## ADDENDUM NO. 02 JUNE 29, 2023

Your attention is directed to the following interpretations of, changes and additions to the Contract Documents for the project, "Hyperspace Vending" at Syracuse Hancock International Airport (SYR) in Syracuse, New York.

VENDING PROJECT SYRACUSE AIRPORT 1000 Colonel Eileen Collins Blvd, Syracuse, NY 13212

1 PARTIAL FIRST FLOOR PLAN - AREA A  
1/4" = 1'-0"

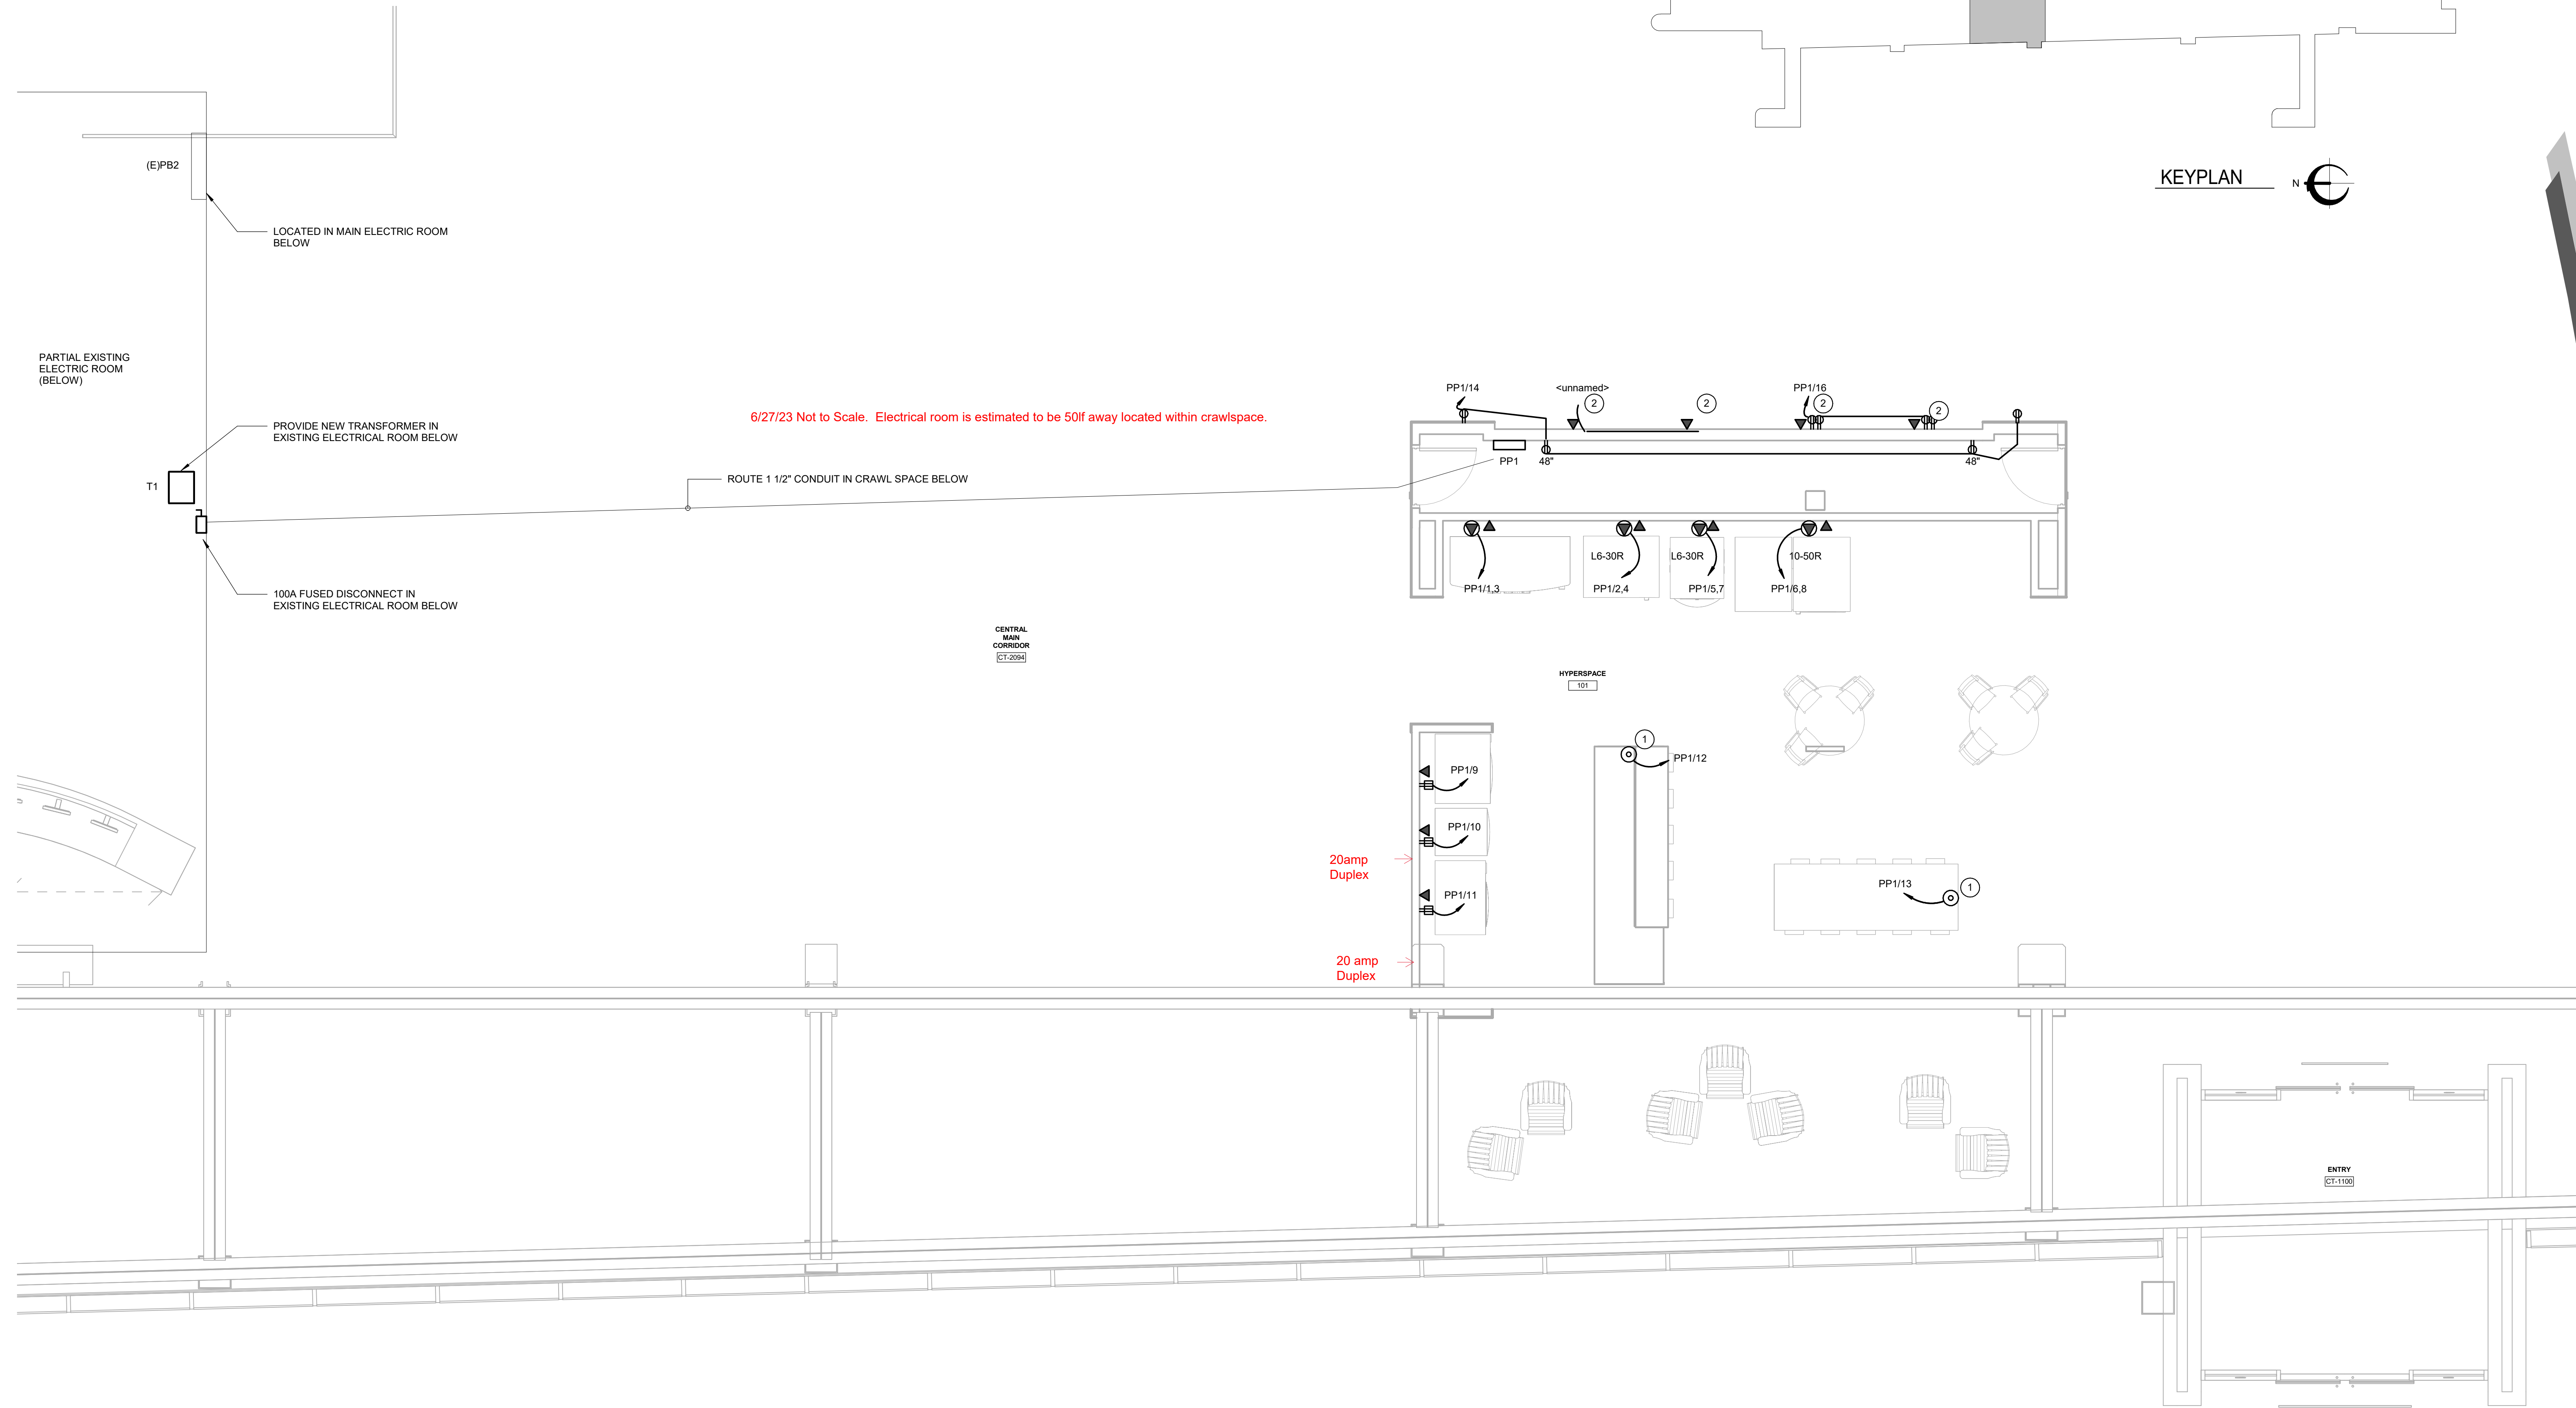
6/27/23 Not to Scale. Electrical room is estimated to be 50ft away located within crawlspace.

PARTIAL FIRST FLOOR LIGHTING PLAN - AREA A

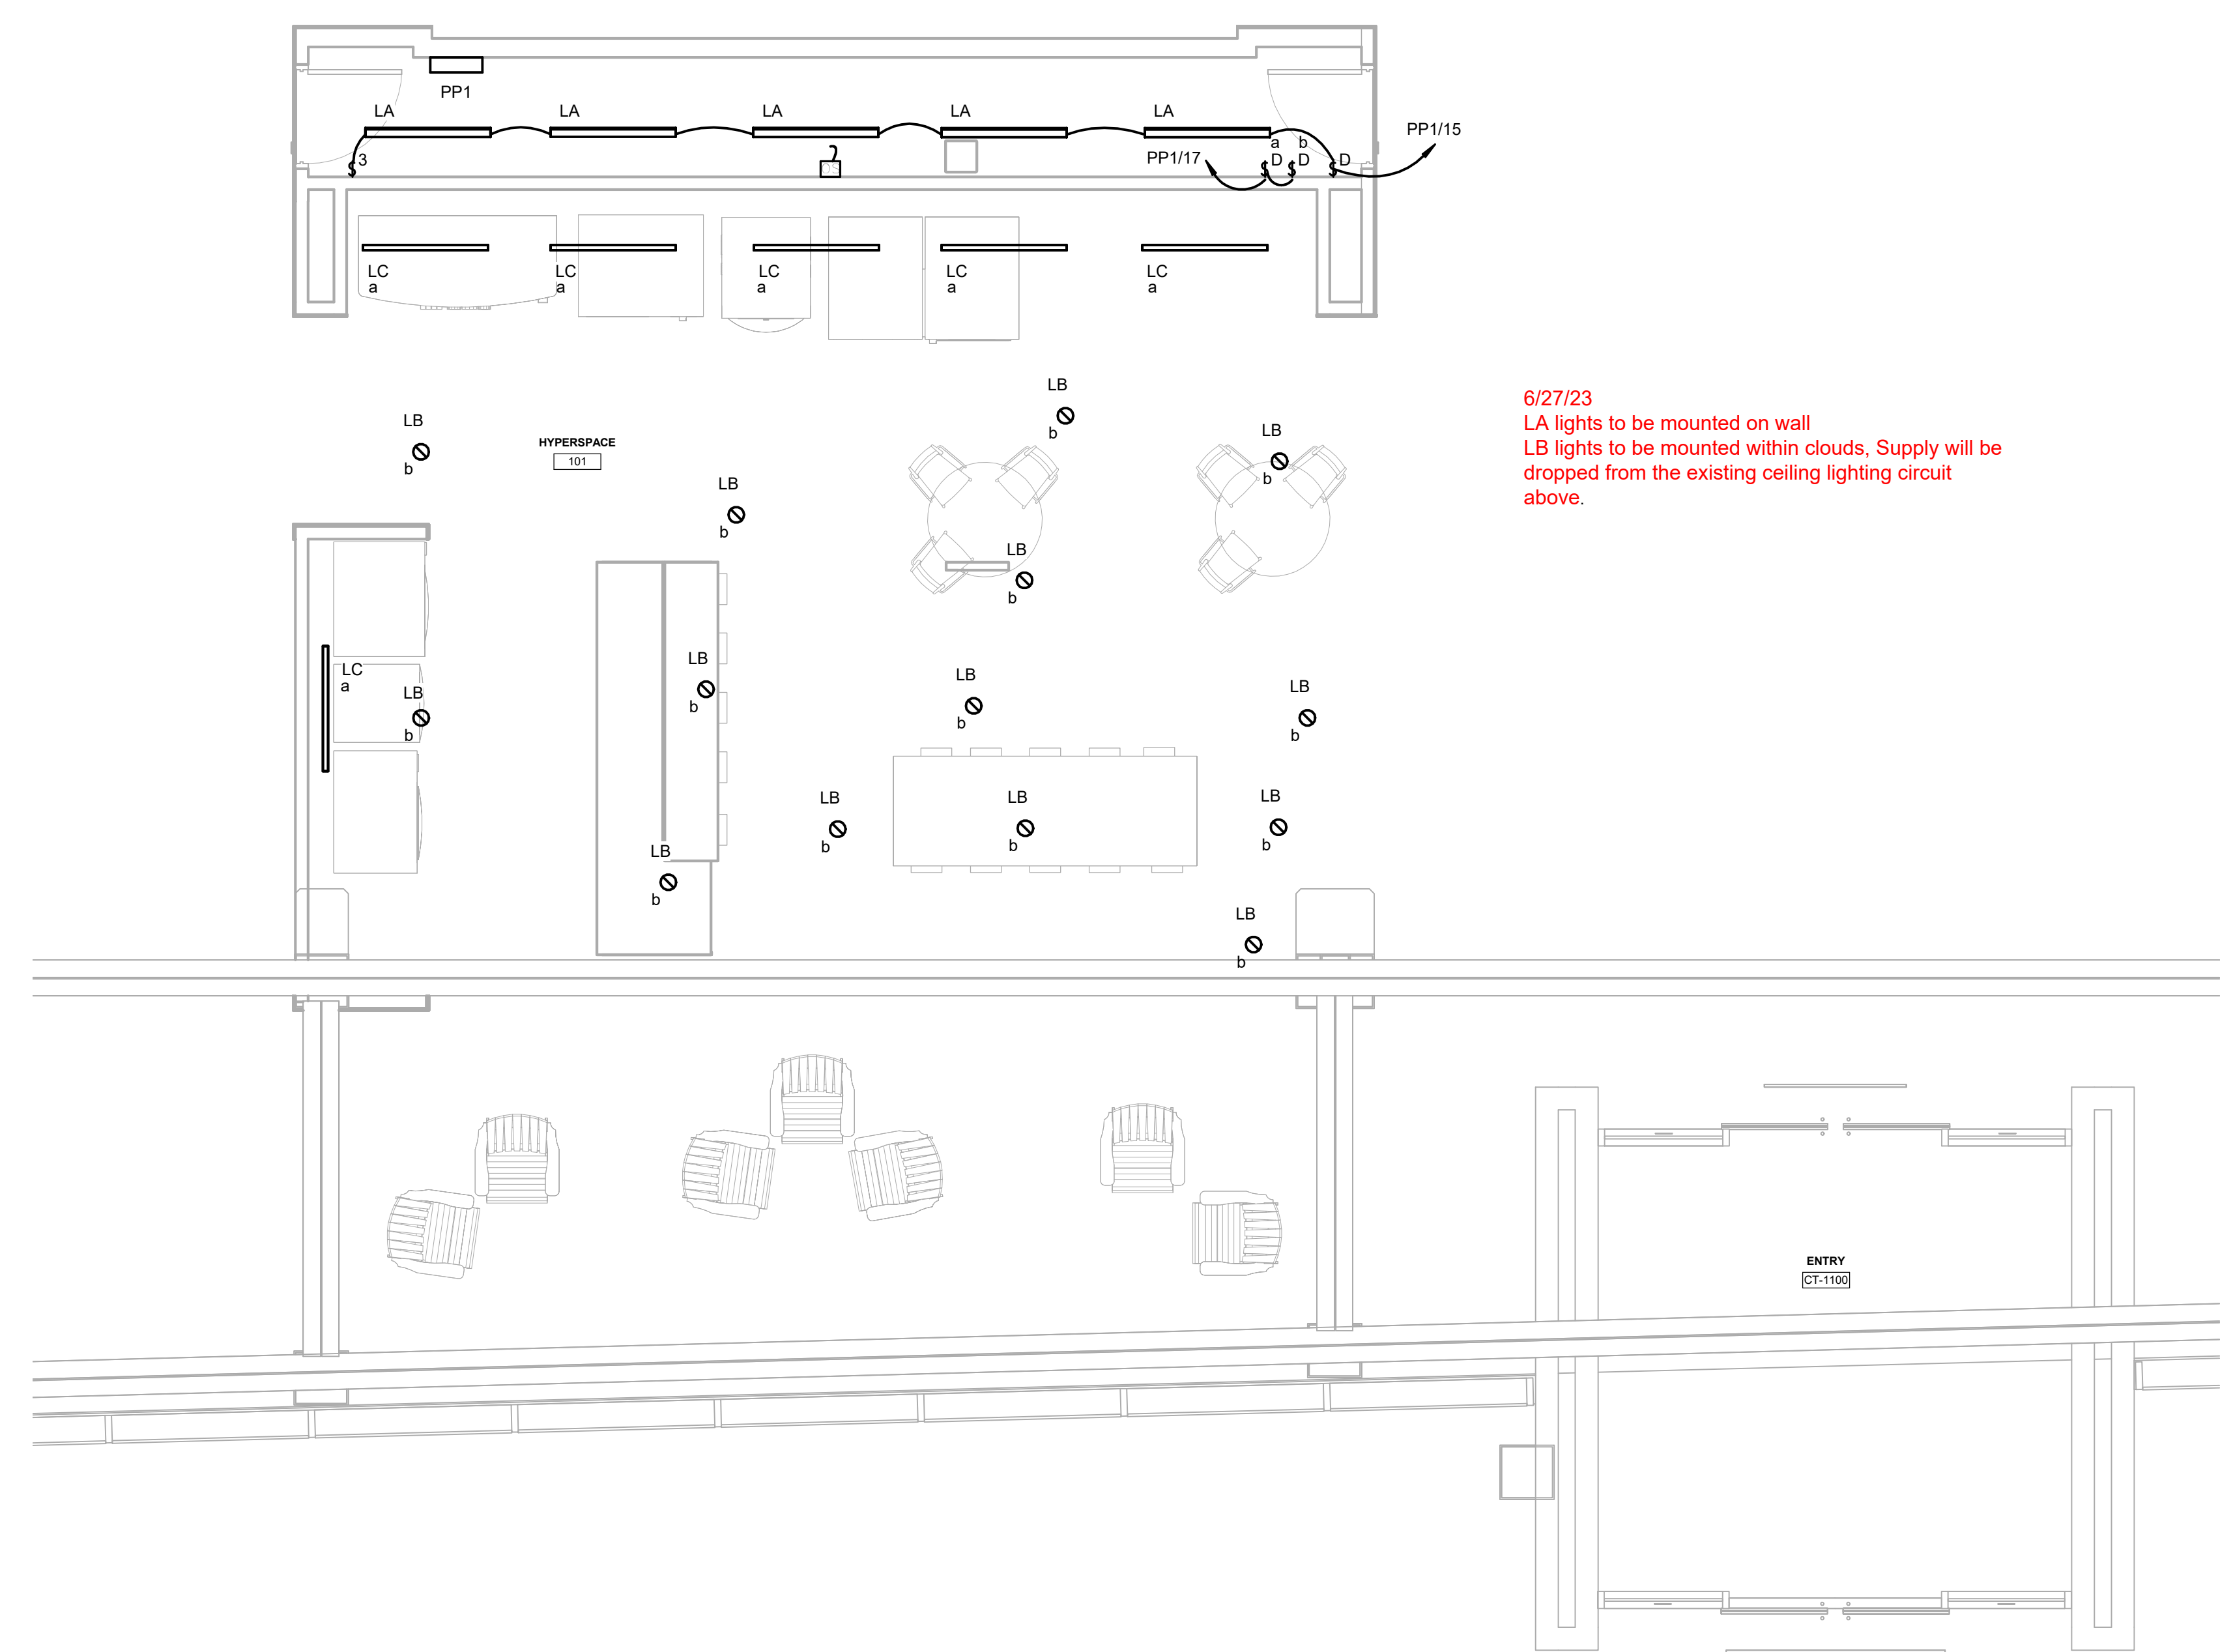
6/27/23  
LA lights to be mounted on wall  
LB lights to be mounted within clouds, Supply will be dropped from the existing ceiling lighting circuit above.

1 PARTIAL UTILITY PLAN  
1/8" = 1'-0"

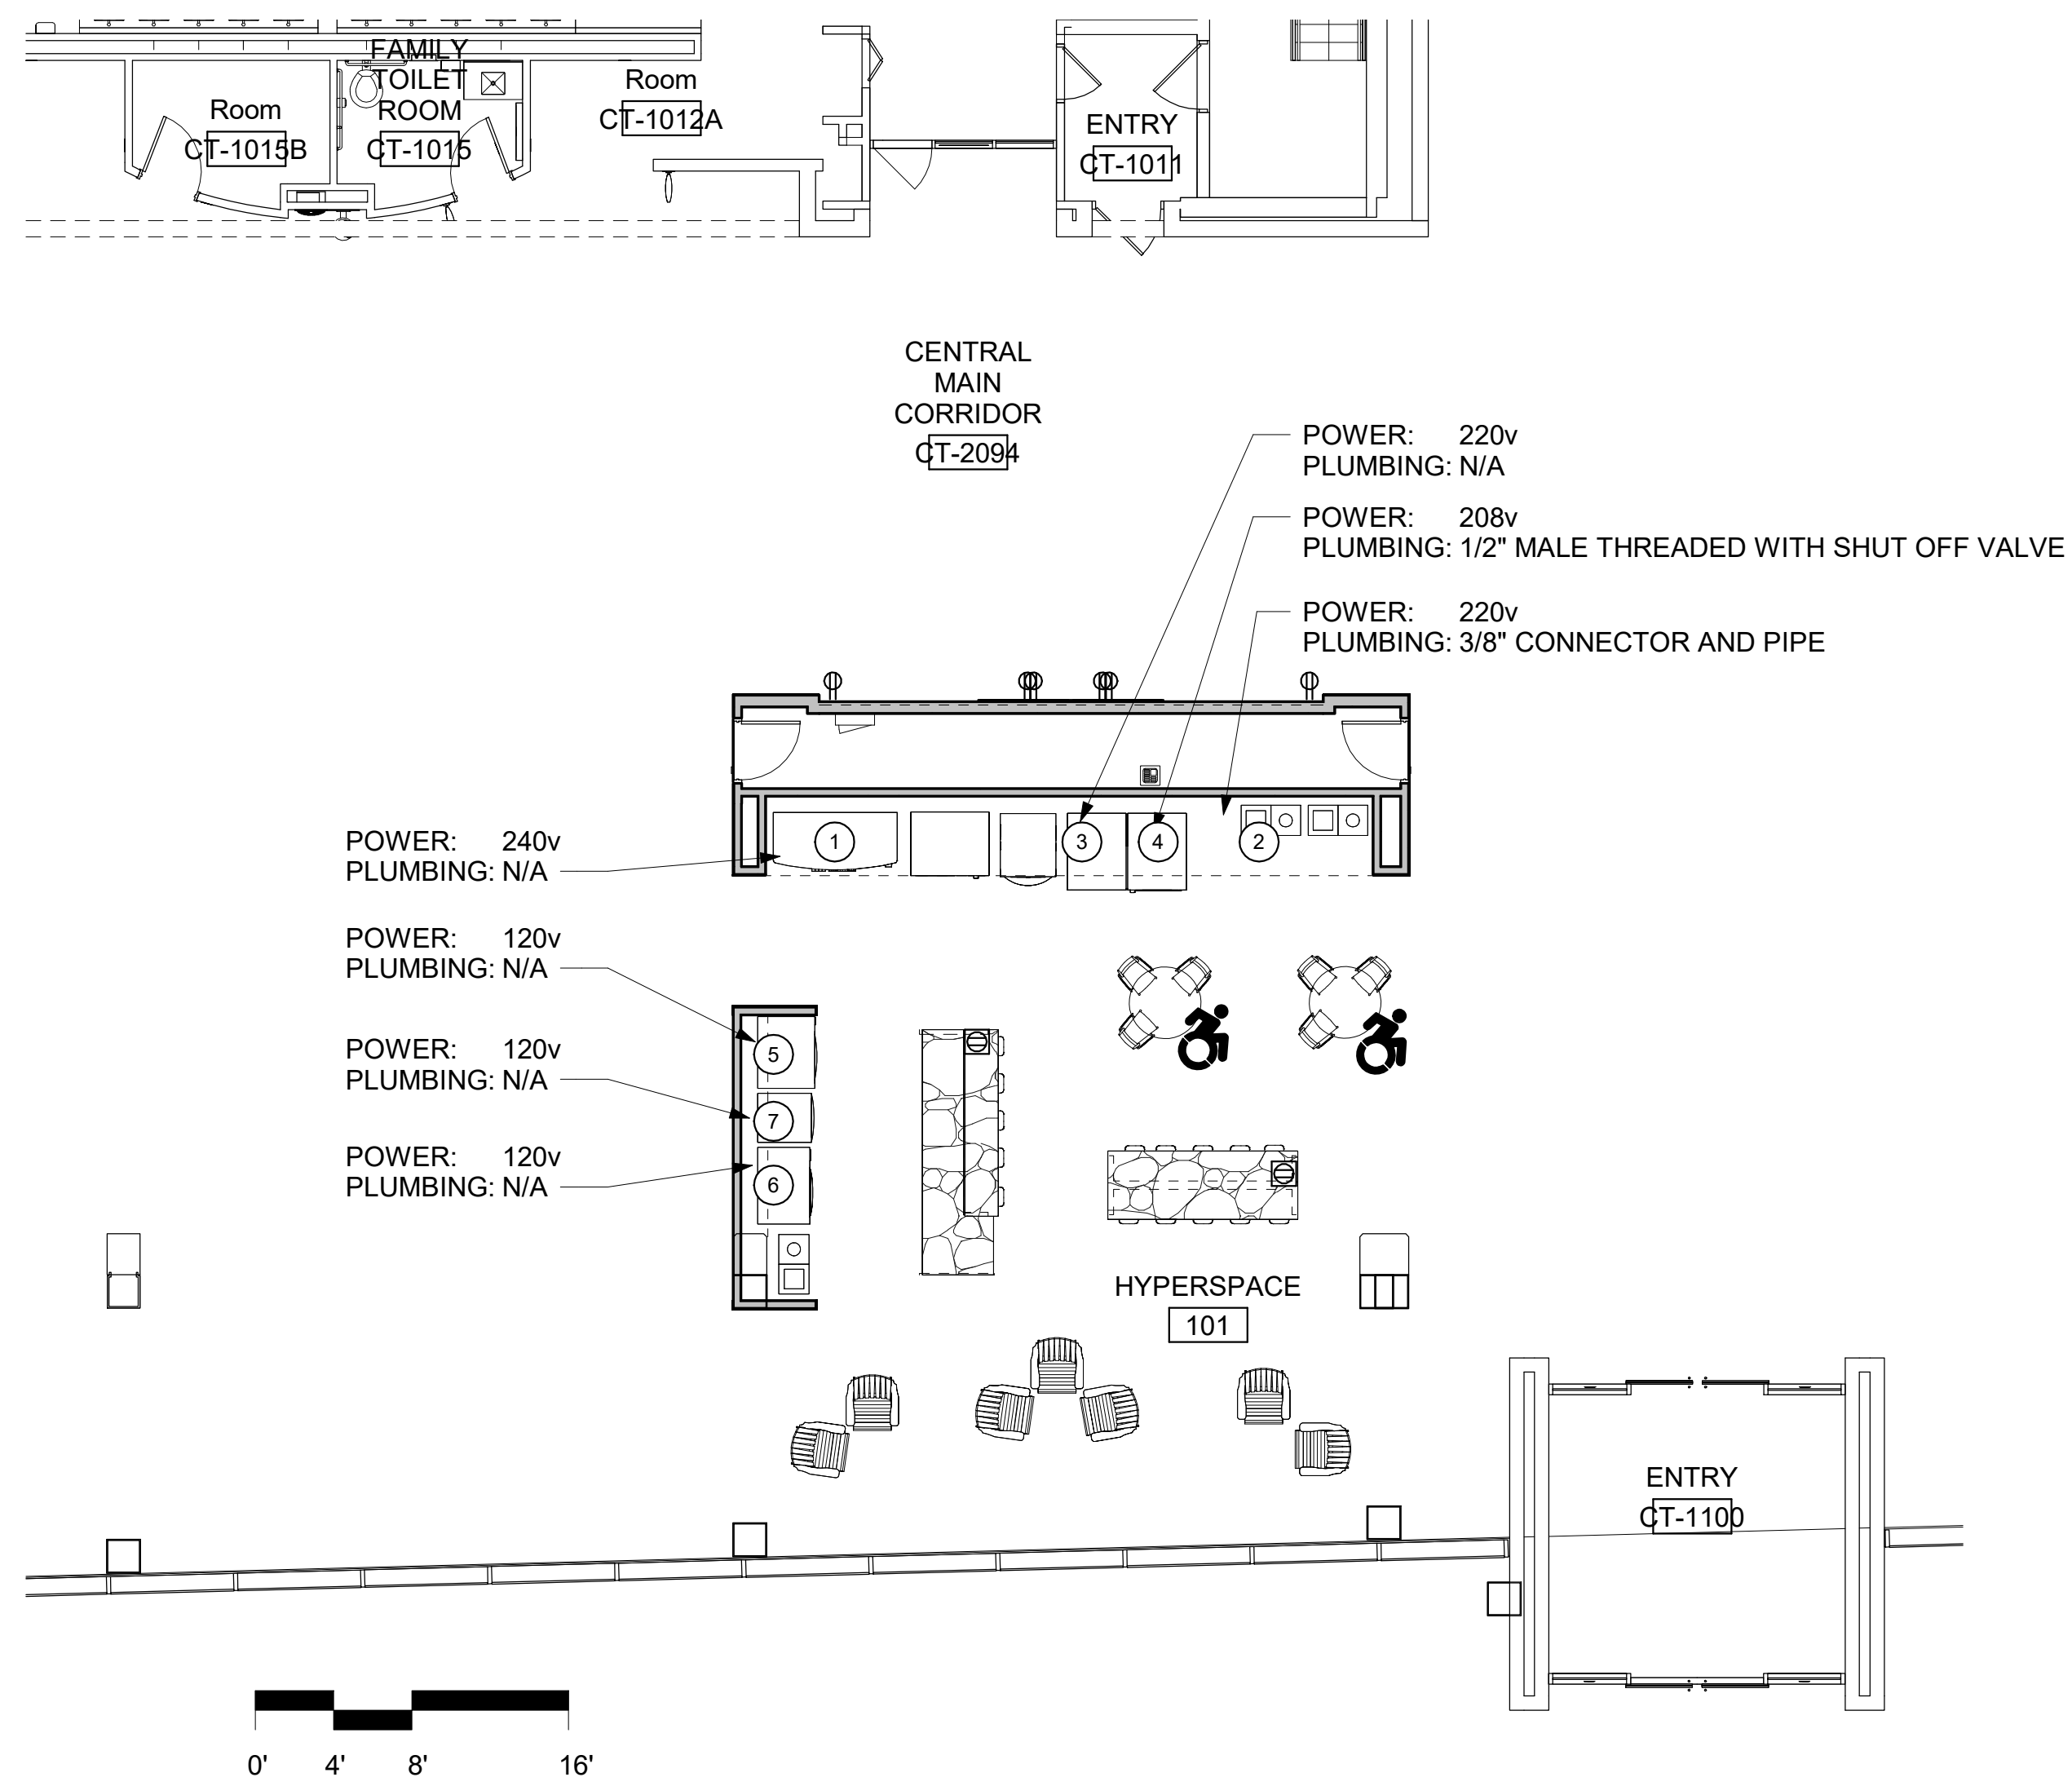
- a. There is a floor sink indicated on plans but no plumbing drain lines shown or sized or where to connect to. Material type? **This was to be reviewed at the walkthrough. Drain and Supply tie ins will be in MEP Room below est. 50lf away.**

- b. Some of the vending machines require water connections and drains. No plumbing for these connections are shown or sized or where to connect to for supply. **See attached drawings and cut sheets for information.**
